Keithley Instruments  
28775 Aurora Road  
Cleveland, Ohio 44139  
1-800-833-9200  
[tek.com/keithley](http://tek.com/keithley)

- Model 2460 High-Current Interactive SourceMeter® Instrument
- 2460-NFP
- 2460-RACK
- 2460-NFP-RACK

**GENERAL Models affected:**

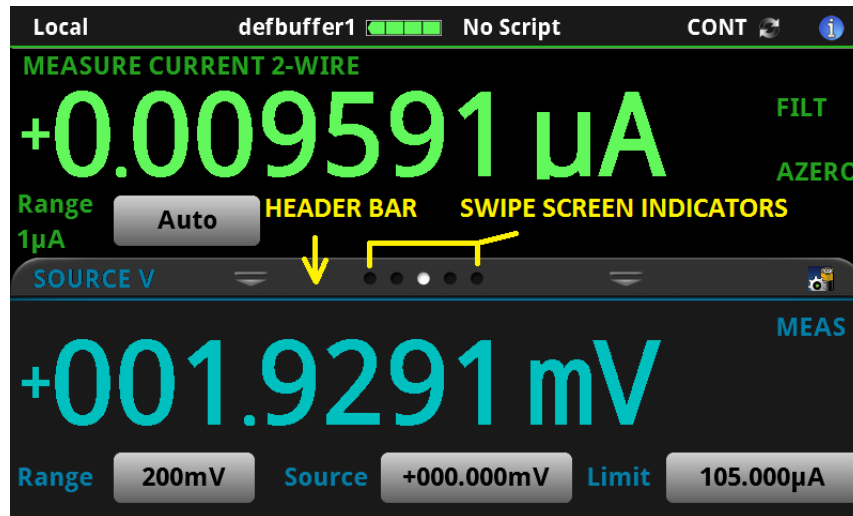
A number of improvements have been made to the overall Graphical User Interface as follows:

1. Screen Colors: All screen colors have been modified for better contrast and easier readability.
2. Pinch-to-Zoom Performance: Throughout the user interface, the “Pinch-to-zoom” touch screen motion has been improved and is more responsive.
3. Improve Swiping:
  - a. The swipe user interface gesturing has been dramatically improved and is more responsive.
  - b. Added Vertical Swiping in various screens in the GUI.
  - c. Horizontal swiping has been made more smooth and is consistent with Vertical Swiping.
  - d. “Fling” swiping has been implemented where faster swiping actions result in rapid scrolling followed by decay based on the velocity of the “fling.”
  - e. Swipe Down on the Home screen will display larger readings.
